SB-GA8-2017-175

Service Bulletin

Installation of oil pressure transducer and USB download port.

Figure 1 – Rear view of rear indicator

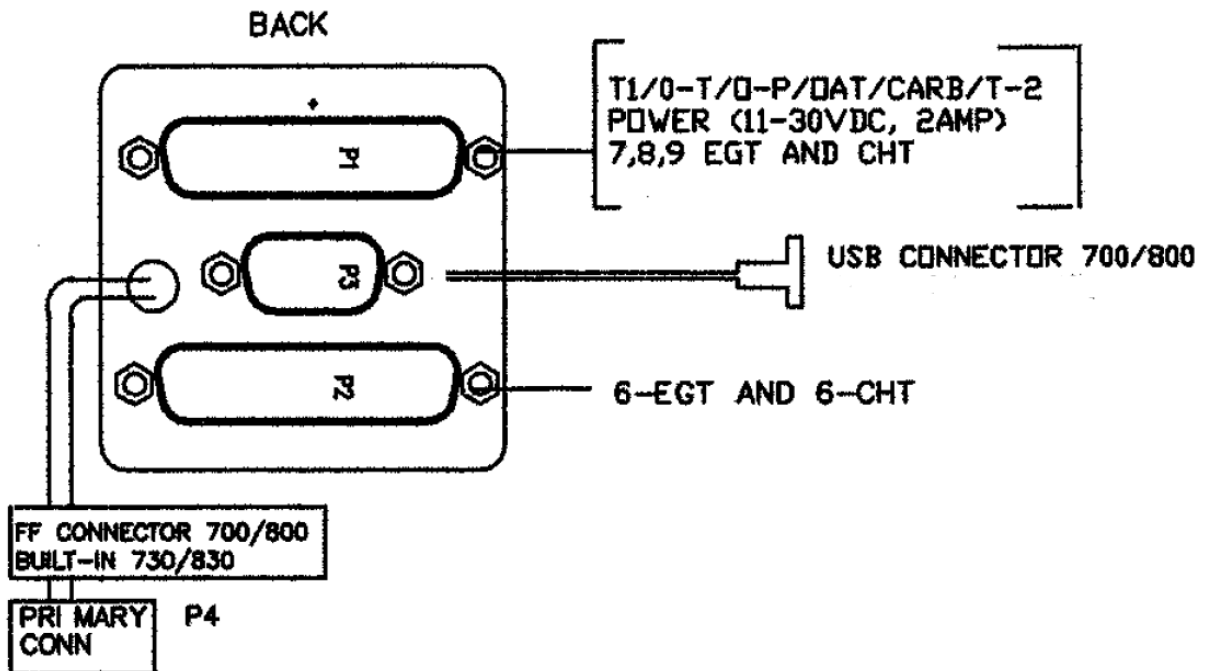
1. Make the aircraft safe for maintenance by pulling all under floor electrical circuit breakers.
2. Check the back of the EDM 800 to see if there is a USB connector tail exiting the rear of the indicator case. Refer to Figure 1.
3. If there is no USB connector, this Service Bulletin cannot be completed until the EDM 800 display unit is returned to JP Instruments for the installation of this feature.

Figure 3 - Installed J.P. Instruments transducer

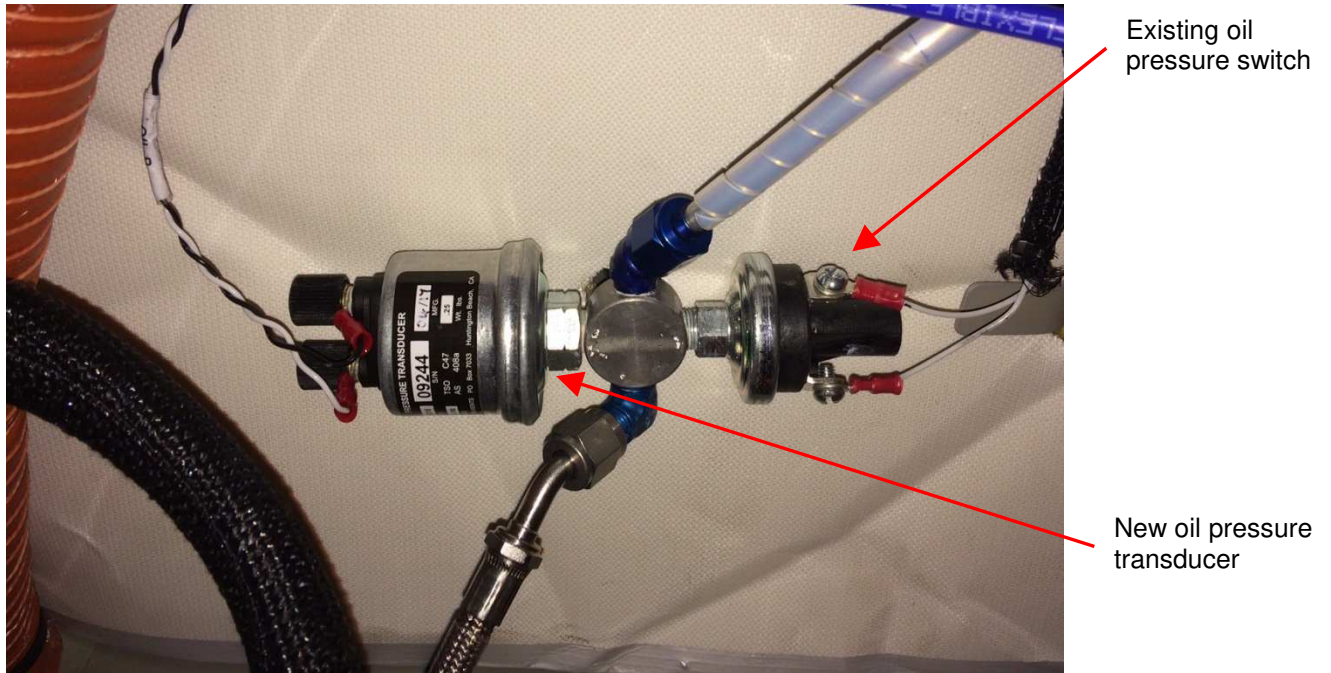
- 1.6. Ensure the thread of the oil pressure sensor fitting is clean of all contaminants (oil, thread sealant etc.). If required, a 1/8 - 27 NPT tap may be used to clean the threads, without removing any metal from the part.
- 1.7. Fit the JPI transducer to the oil pressure sensor fitting using Loctite 567 thread sealant.
- 1.8. Remove the blanking plugs from the oil lines and reinstall the oil pressure sensor fitting to the aircraft.
- 1.9. Wipe up any remaining oil residue.
- 1.10. Route the 2 transducer wires from the indicator connector J3 to the installed transducer. Refer to Figure 3. Route the wires with existing wire routing running along the fire wall. The routing shall ensure that no chaffing can occur.

- 1.11. Terminate the wires with ring terminals supplied with the JPI kit.
- 1.12. Fit the terminated wires to the sensor and firmly tighten the locking nuts to the transducer. There is no polarity on the oil pressure transducer wires.
- 1.13. Place the EDM 800 into program mode in accordance with Installation Manual for EGT 701 Report 103.
- 1.14. Configure the programmable parameter "OIL P" in accordance with Service Manual Supplement C05-96-55 at latest issue.
- 1.15. Power cycle the indicator.
- 1.16. Place the EDM 800 into program mode in accordance with Installation Manual for EGT 701 Report 103.
- 1.17. Set the parameter "O-P" in accordance with Service Manual Supplement C05-96-55 at latest issue. Note the default value from JPI is 20 for this parameter & therefore should not require any change.
- 1.18. Power cycle the indicator.

Figure 4 - Location of panel mounted USB port

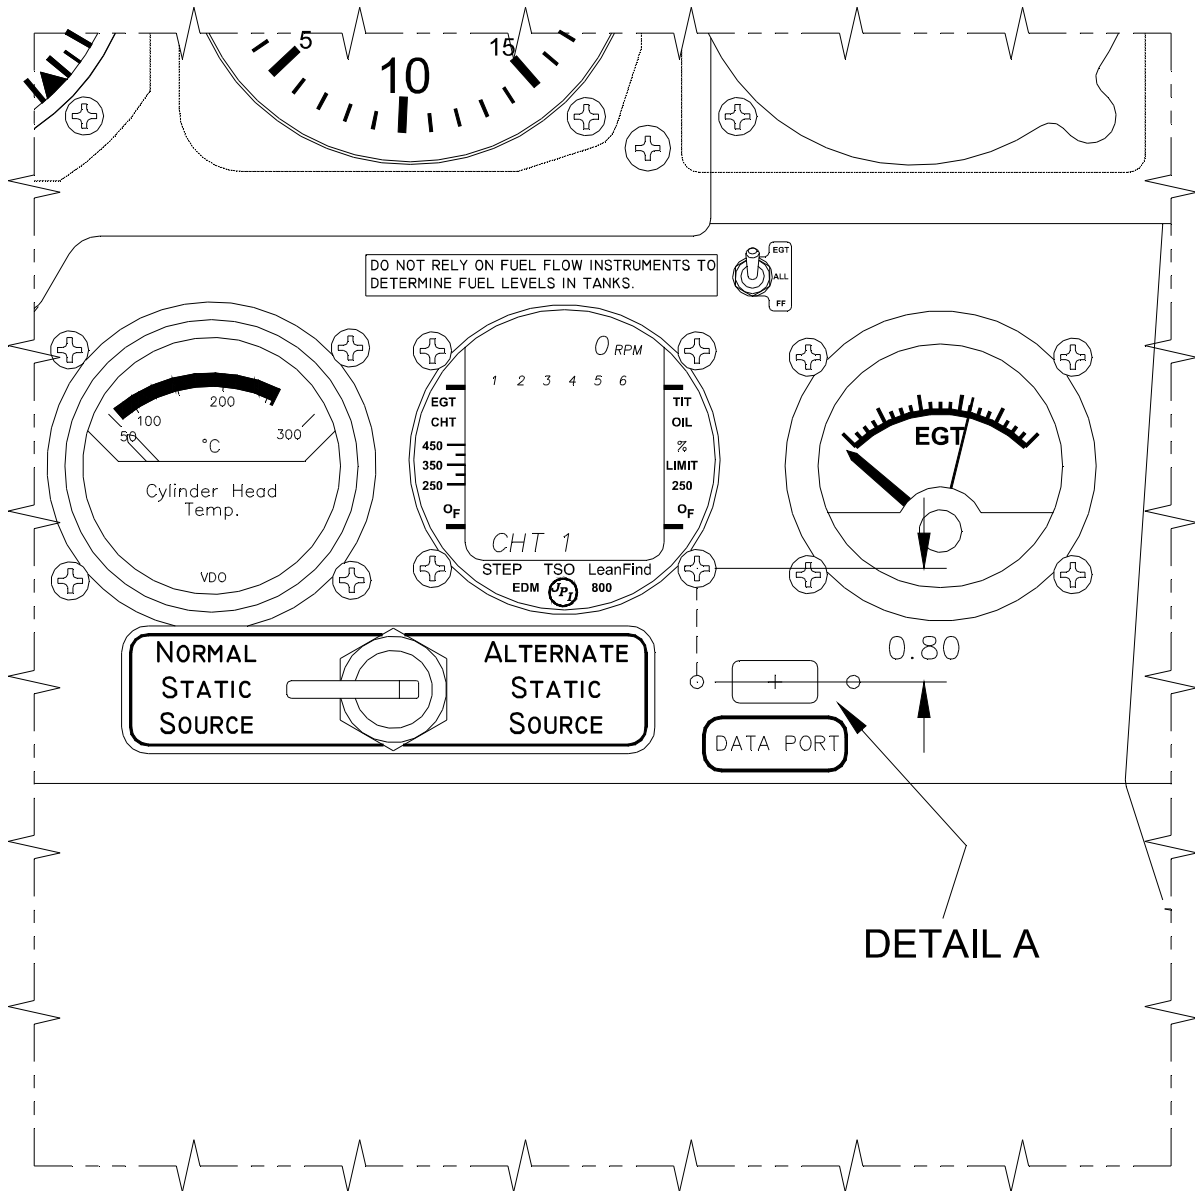
2.1. Two locations for the USB port are allowed and are given in Figure 4 & Figure 5. Review the existing installation configuration of the aircraft cockpit before proceeding. The location shown in Figure 5 for the USB port may be deviated +/- 1.0" laterally from the location shown. The cut out details are provided in Figure 6. The location as described by Figure 5 will not interfere with the movement of the control column. Figure 4 is viewed looking straight at the instrument faces. Figure 5 is viewed looking at the instrument panel in a horizontal plane.

2.3. Locally fabricate a placard stating "DATA PORT" and fit immediately adjacent to the USB connector as shown in Figure 4 & Figure 5, subject to data port location selected.
